DEPARTMENT OF TRANSPORTATION**Federal Aviation Administration****14 CFR Part 39**

[Docket No. FAA–2009–1088; Directorate Identifier 2008–SW–76–AD]

Airworthiness Directives; Sikorsky Aircraft Corporation Helicopters

ACTION: Supplemental notice of proposed rulemaking (NPRM); reopening of comment period.

Figure 1-2A to Paragraph (d), Maximum Gross Weight for HEC Requiring Cat 'A'

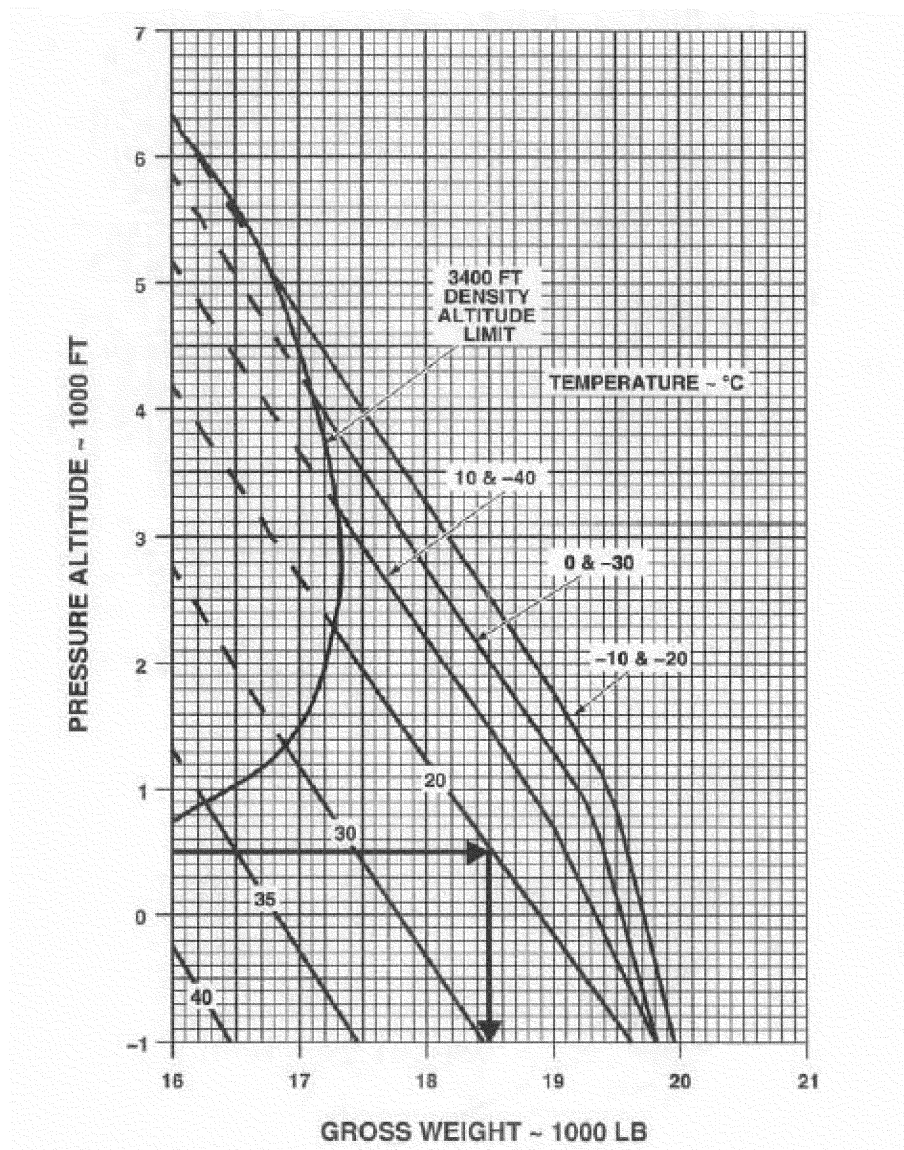
(ii) Add this paragraph and figure: “HOIST Maximum gross weight for Human External Cargo, which requires category ‘A’

performance capabilities, is limited to the gross weight determined in accordance with the following Figure 1–2A to Paragraph (d) of this AD for your altitude and temperature with the air-conditioner, anti-ice, and bleed air turned off.”

NOTE 1 to Figure 1-2A to Paragraph (d) of this AD: THIS CHART DEPICTS THE GROSS WEIGHT, PRESSURE ALTITUDE, TEMPERATURE COMBINATION WHERE OEI HOGE CAPABILITY EXISTS USING 30 SECOND OEI POWER WITH A 60 SHP MARGIN.

NOTE 2 to Figure 1-2A to Paragraph (d) of this AD: 15 FT OF GROUND CLEARANCE IS ASSURED IN THE EVENT OF AN ENGINE FAILURE AT 20 TO 80 FT AGL.
